**ADDENDUM NUMBER 2**

**Thursday, January 23, 2025**

**PROJECT: BRISCOE PARK  
COMMUNITY CENTER, GA  
GMC PROJECT NO. AATL2300037**

**ENLARGED PLANS**  
A1.11  
sheet of

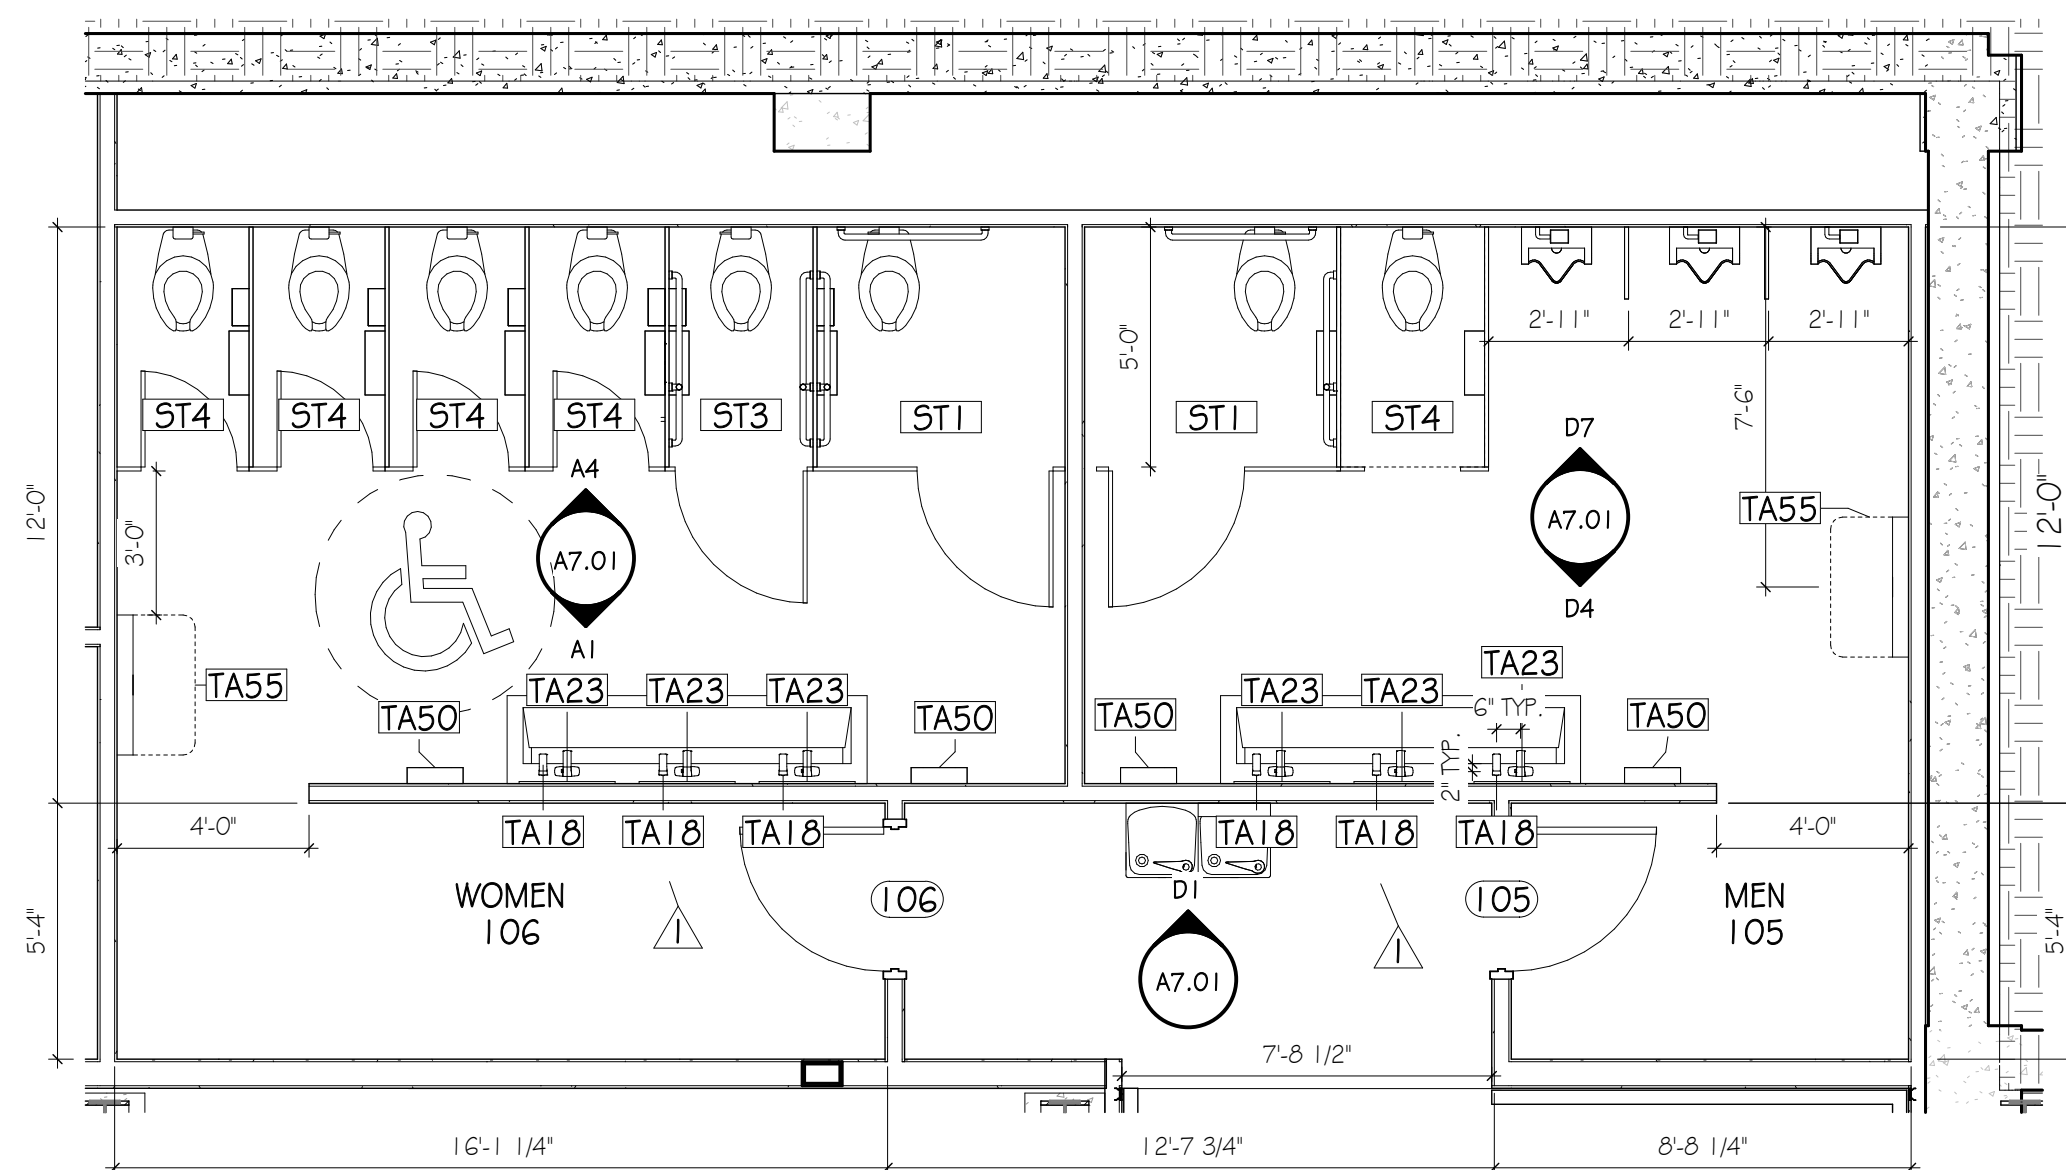
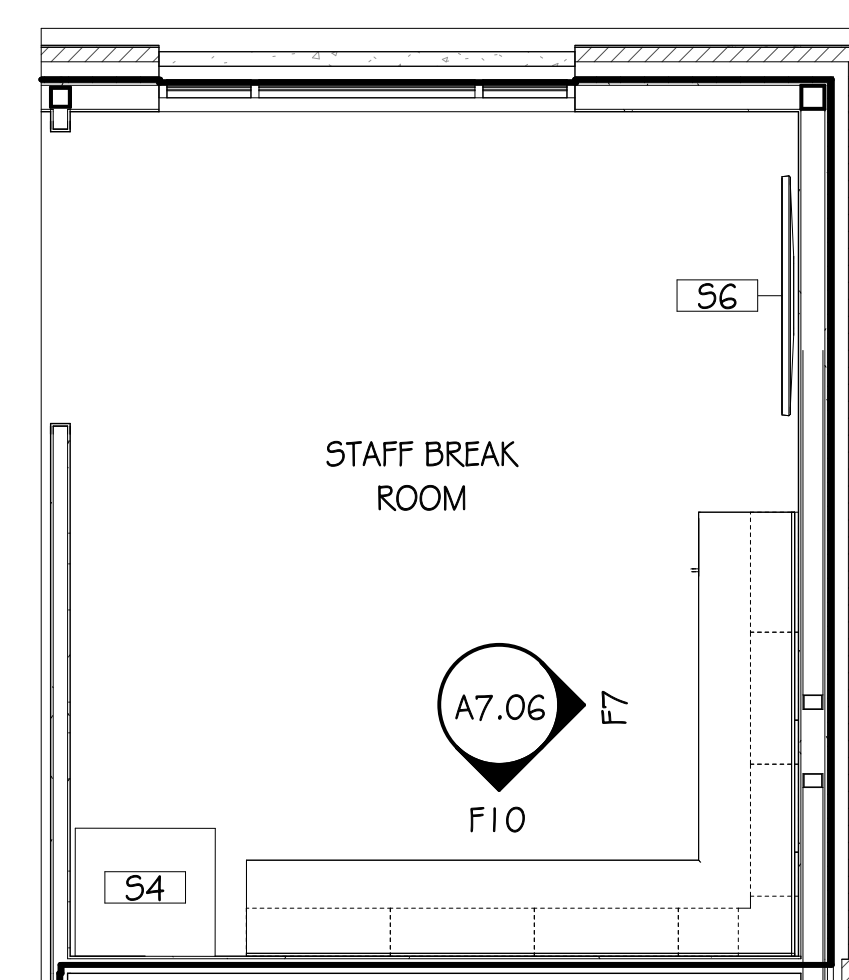
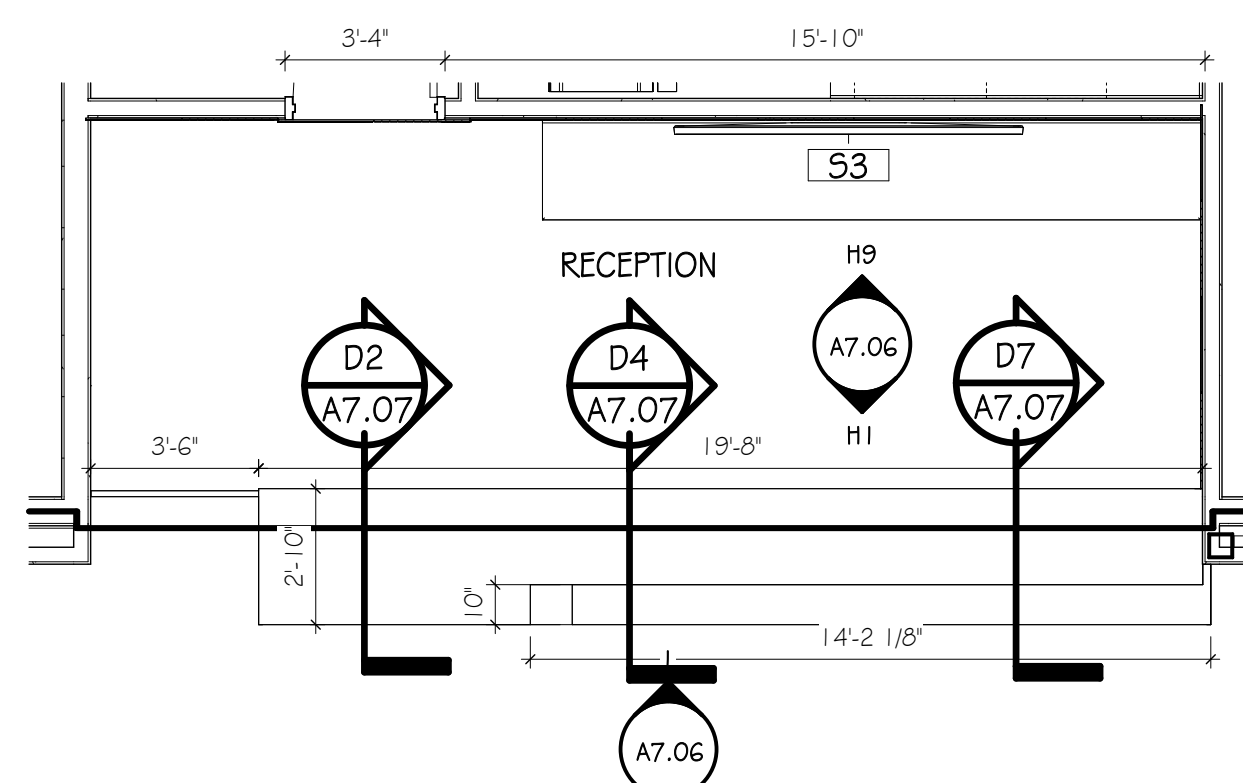
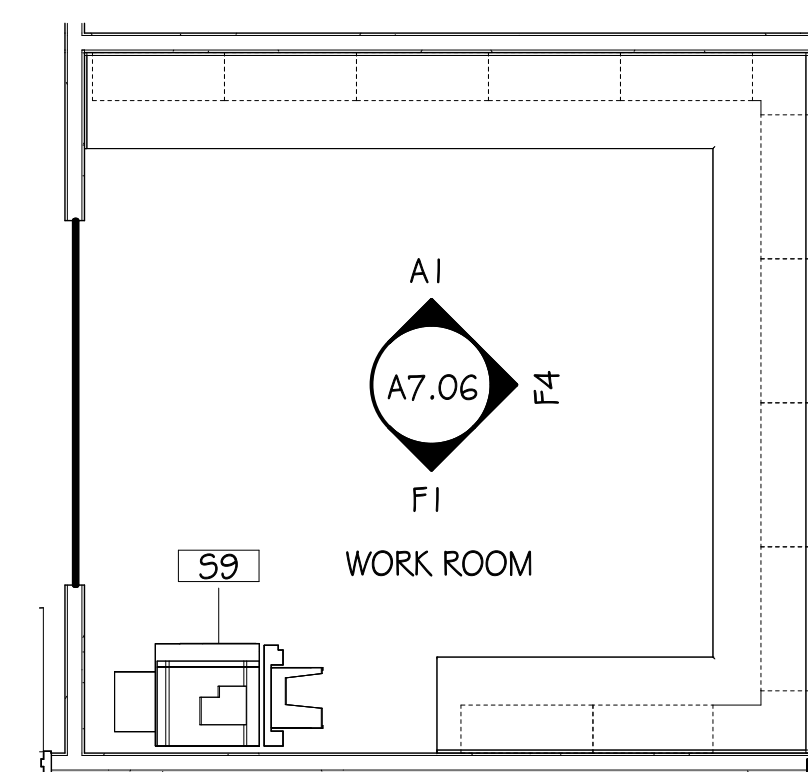
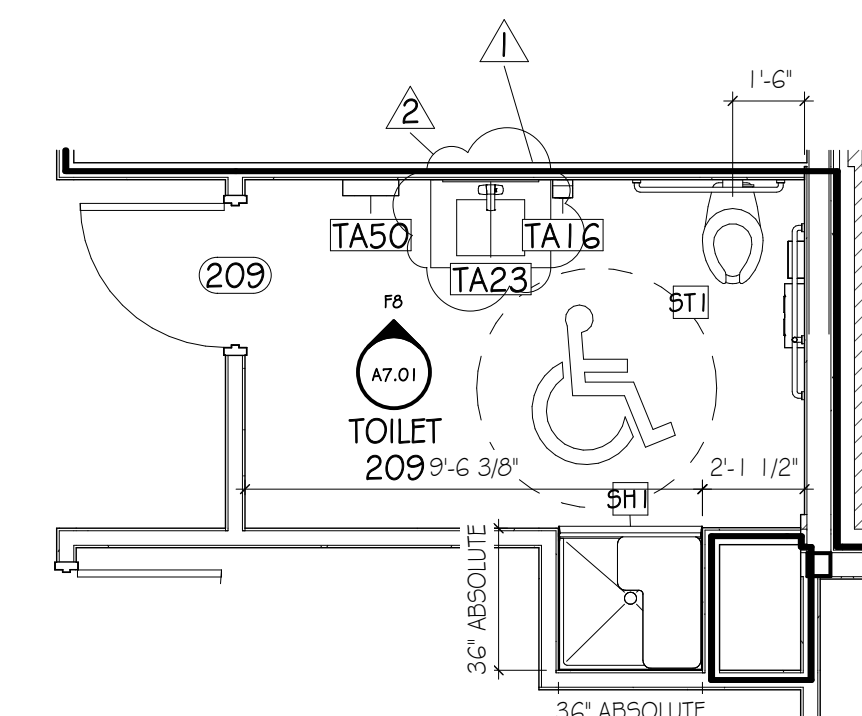
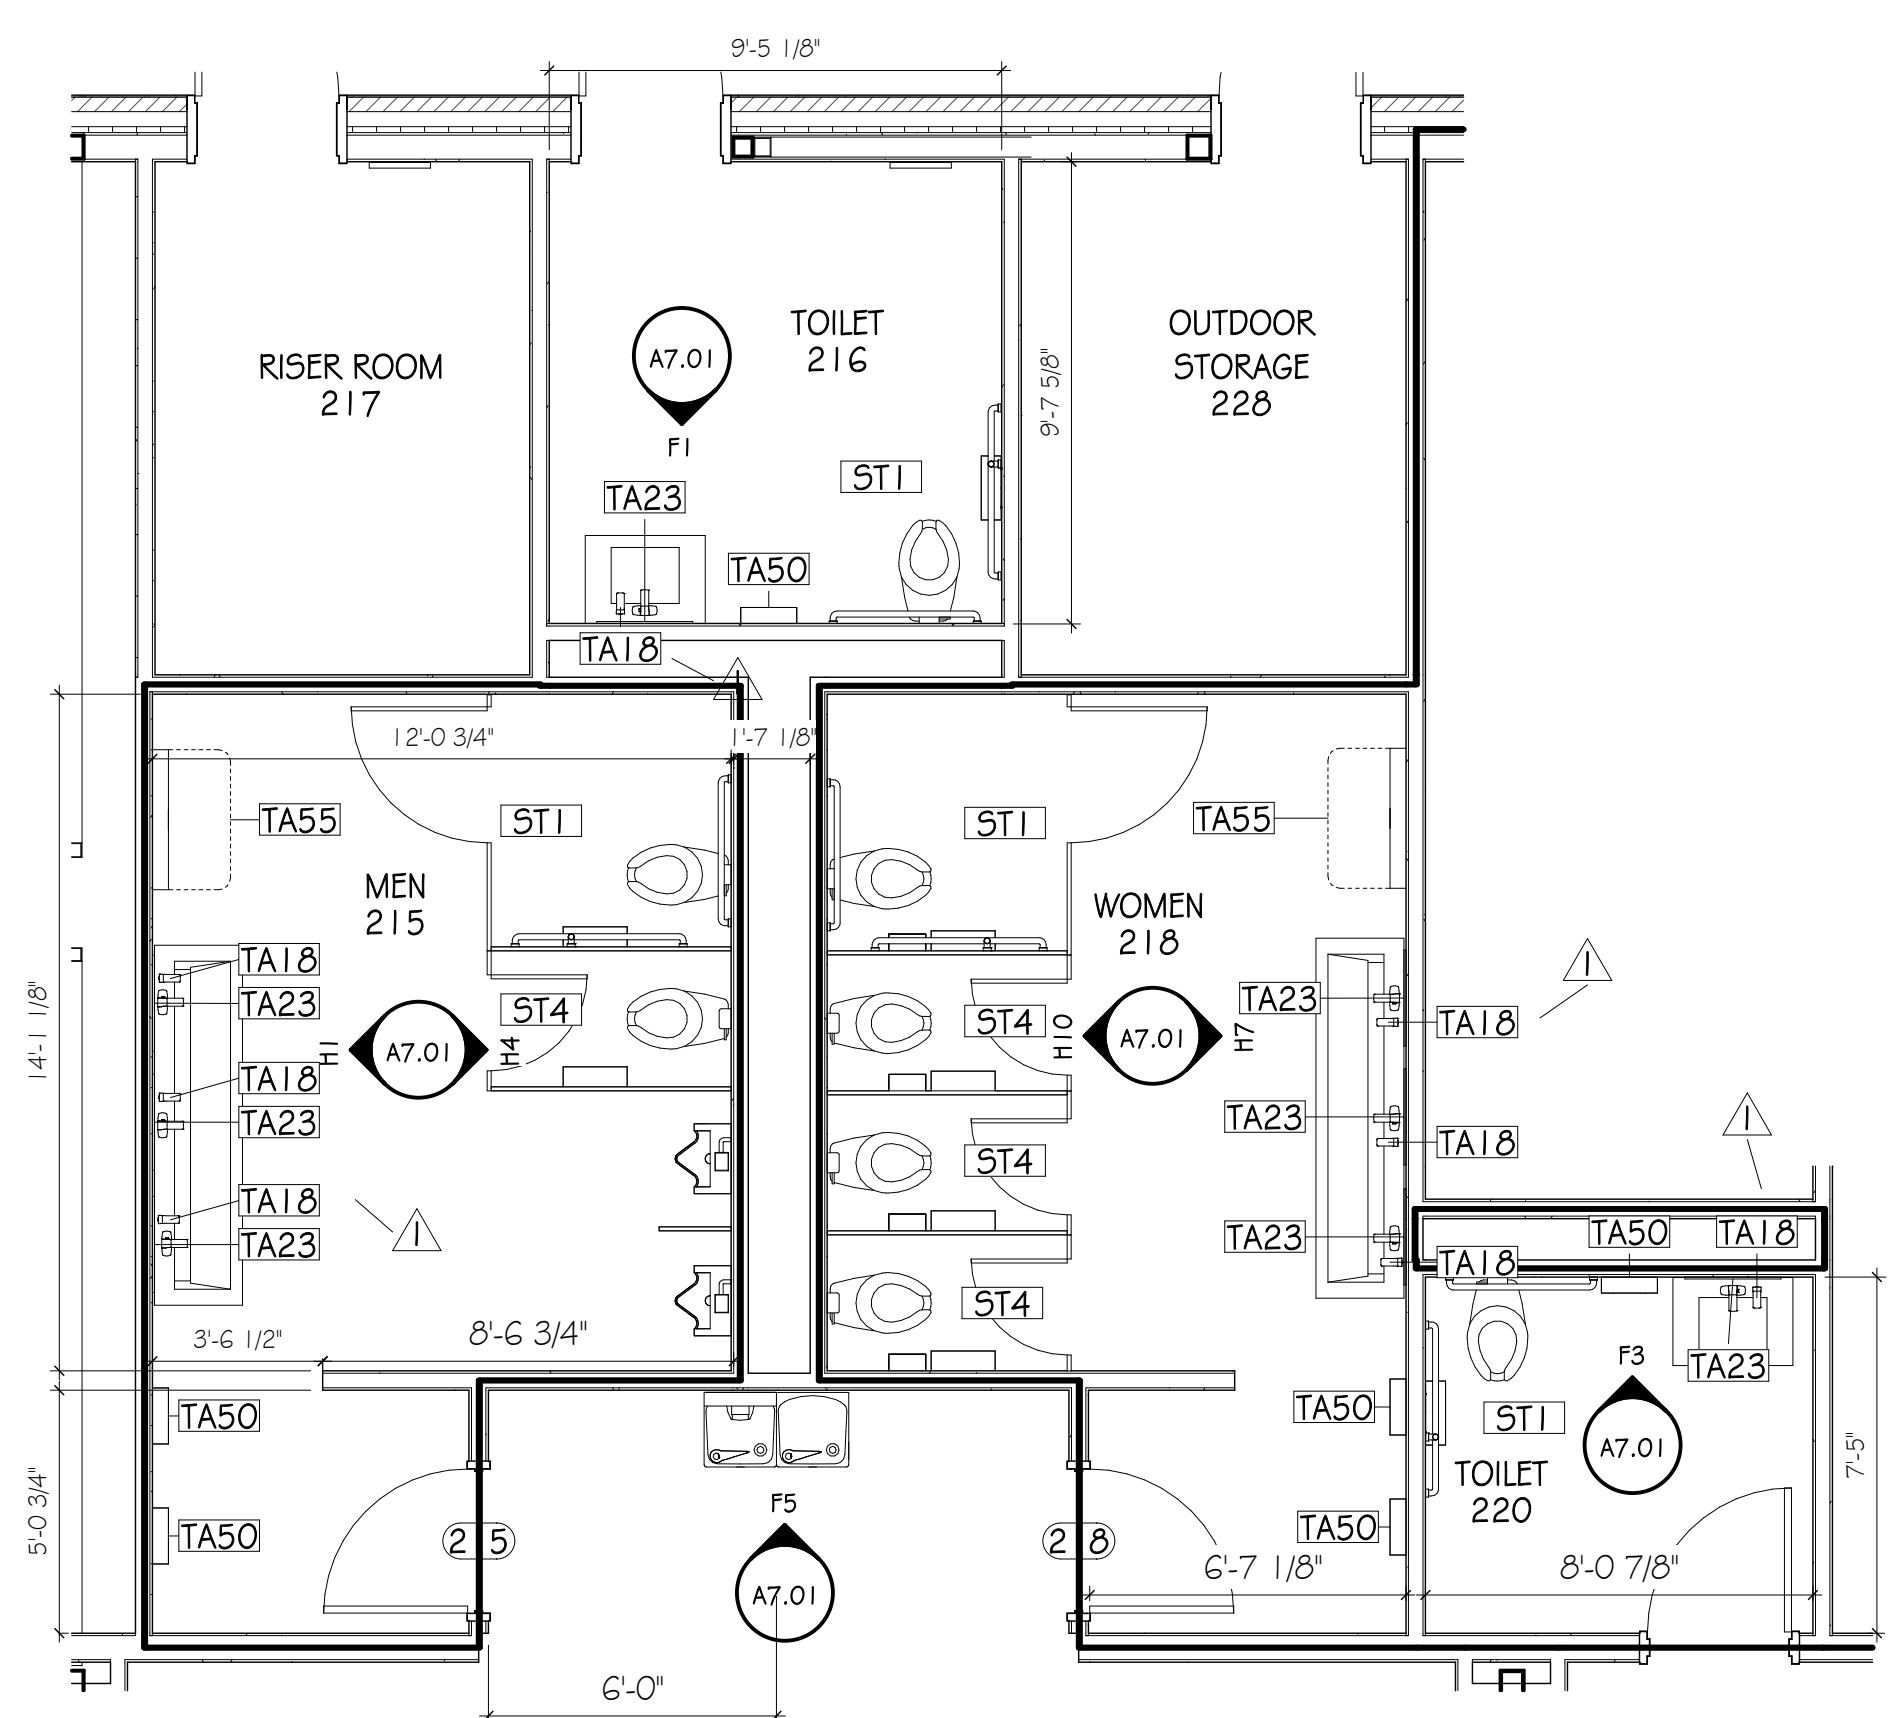
- I. S3.13 – CONCRETE WALL DETAILS
  - 1. Updated to show interior retaining wall elevation
- J. A1.11- ENLARGED PLANS
  - 1. Updated equipment types
- K. A1.21 – PLAN DETAILS
  - 1. Updated wrapped patio pilaster details
- L. A2.01- RCP LEVEL 1
  - 1. Showing roller shade locations and exposed ceiling areas
- M. A2.02- RCP LEVEL 2
  - 1. Showing roller shade locations and exposed ceiling areas
- N. A4.01- EXTERIOR ELEVATION
  - 1. Updated sunshade placements and signage
- O. A4.02- EXTERIOR ELEVATION
  - 1. Updated sunshade placements.
- P. A5.13 – WALL SECTIONS
  - 1. Section of Exterior Patio pilaster.
- Q. A7.01- INTERIOR ELEVATIONS TOILETS
  - 1. Updated type of toilets and finishes
- R. A8.01- FINISH LEGEND AND SCHEDULE
  - 1. Updated paint color.
